ADDENDUM

RFB NO. 317013 - ADDENDUM NO. 1

PRIMATE HOUSE HVAC IMPROVEMENTS

HENRY VILAS ZOO

DRAWING NO.: H-1 1 OF 3

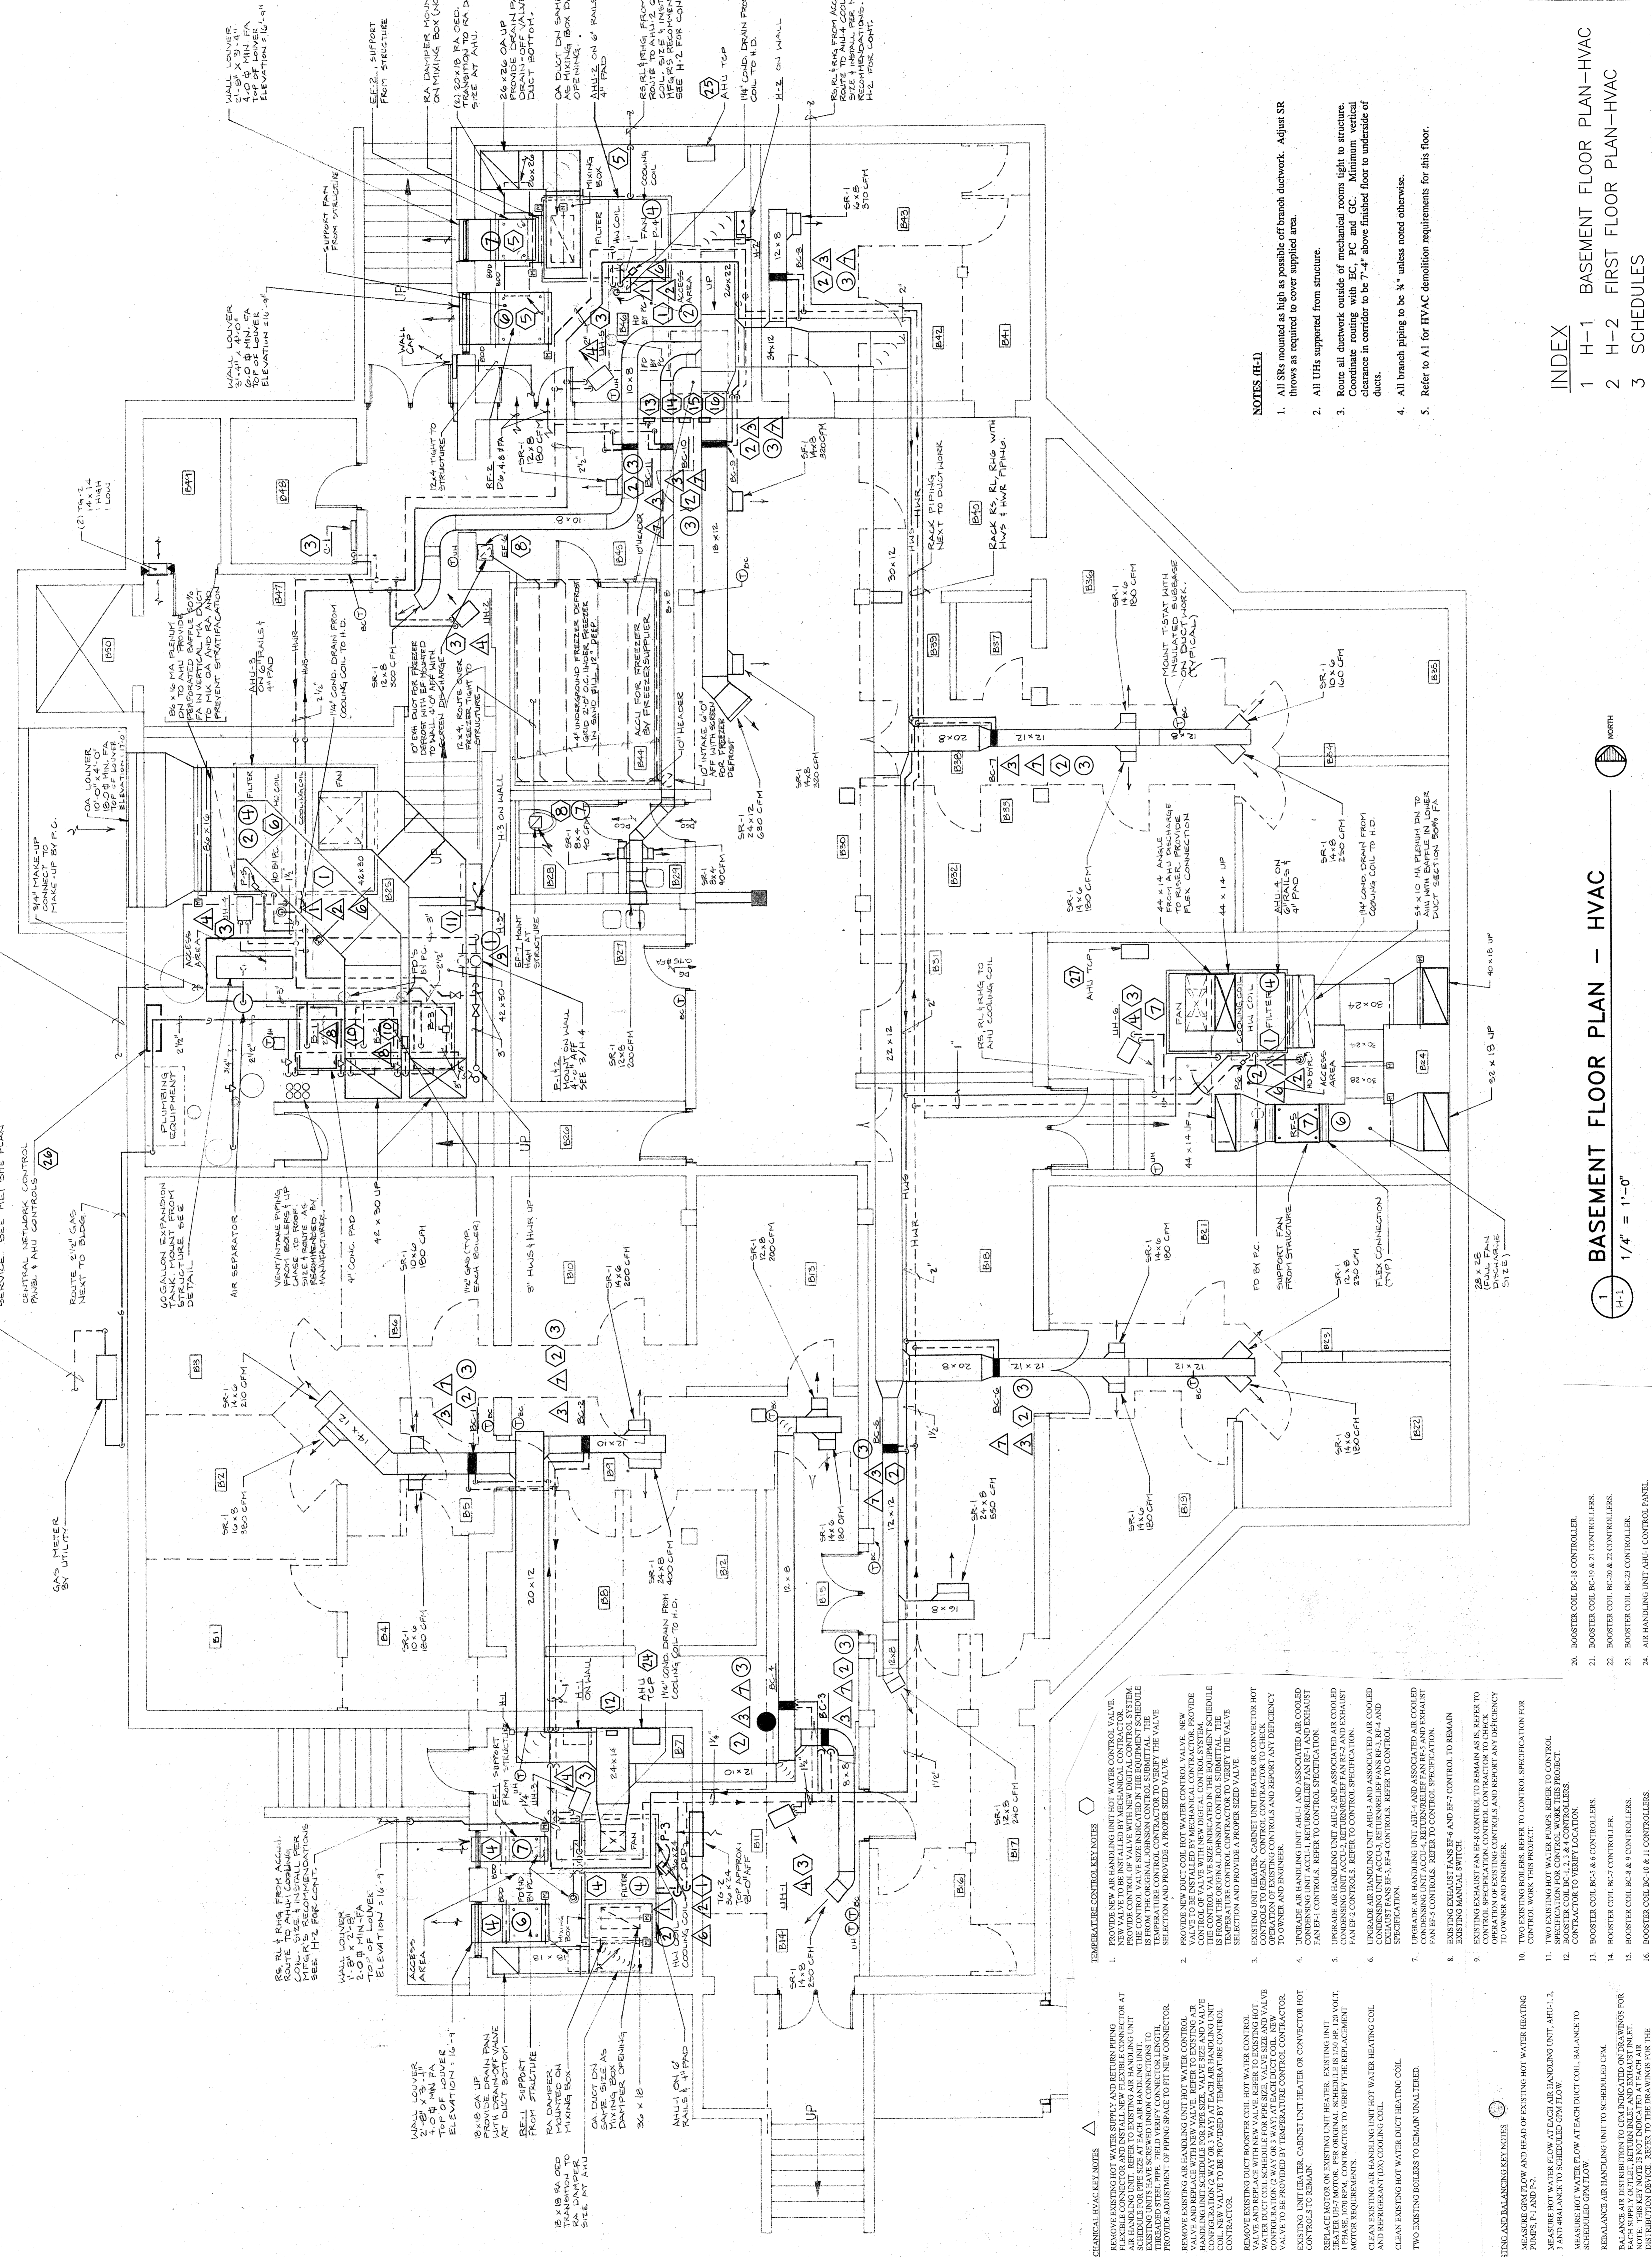
1. Basement Key Plan: New refrigerant piping from ACCU-4 to AHU-4 shall be run into building room B43, through wall into corridor B30, turn into room B18 above double doors and run into AHU-4 Mechanical Room. Keep piping as high as possible. Existing refrigerant piping above rooms B31, B32, B40, and B42 may be abandoned in place.
2. Sheet H-1 Basement Floor Plan – HVAC (from Original Drawing Set for HVAC Controls Upgrade by Arnold & O'Sheridan, Inc. revision dated 7/3/2012) is included for Reference.
